This page lists the know errors on the gm5x5x5 PCBs. There are no known issues with the bulk order run (white pcbs), the following information is valid **only** for the prototype run (green pcbs).

Bulk Order #1 (white PCBs, rev 1.0)

Prototype Run (green PCBs)

#1 MIDI IO pins

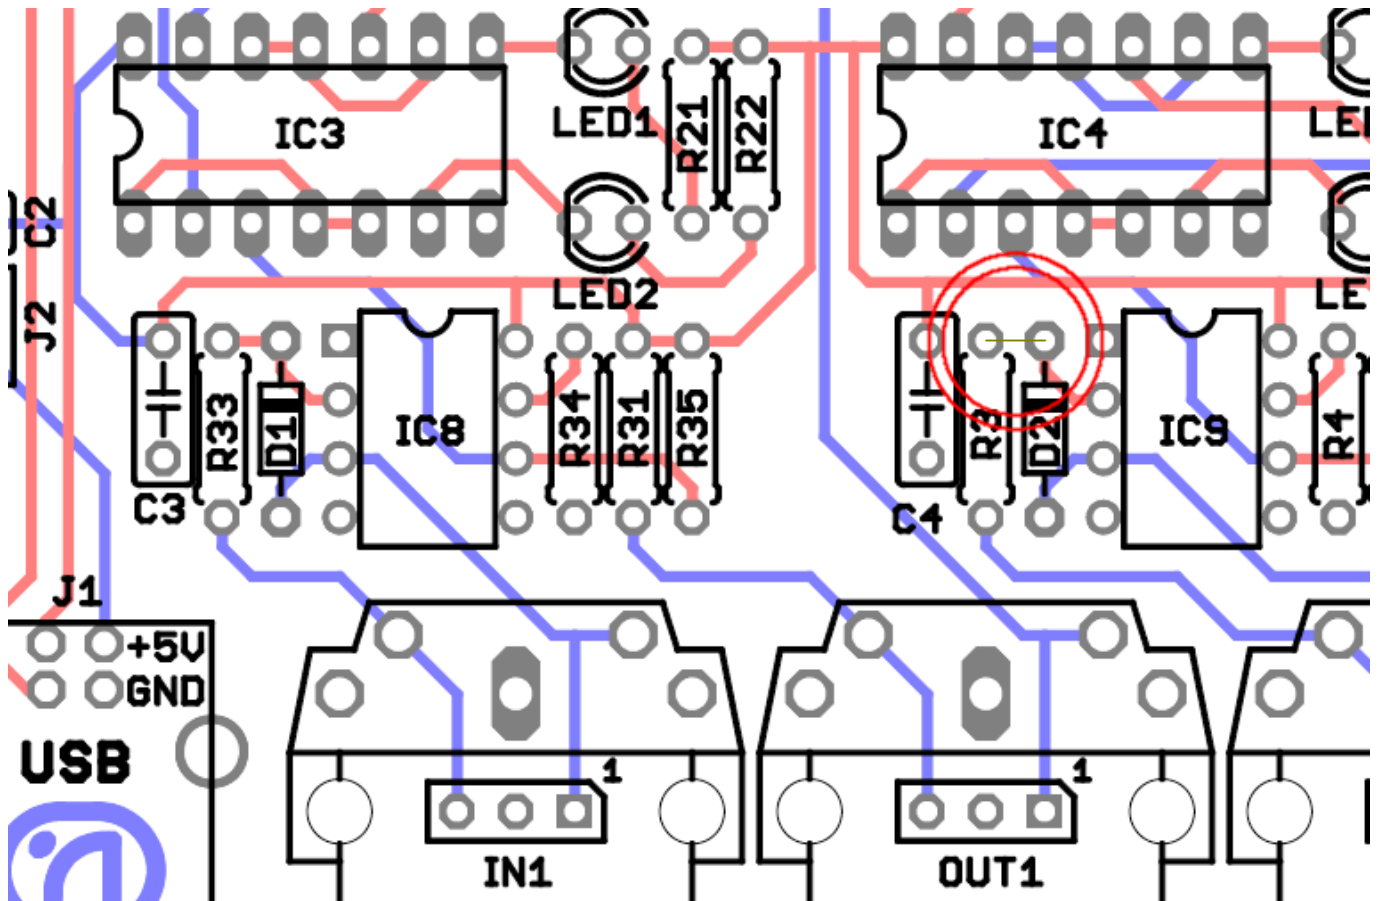
Problem: The MIDI IO pins of the midi sockets (Pin 4 + 5) are switched.

Solution: Either (1) use the pin-headers if you use sockets that are not mounted on the pcb or (2) break the traces to pins 4 + 5 of the sockets and solder wires to them or (3) solder the midi sockets on the other side of the pcb.
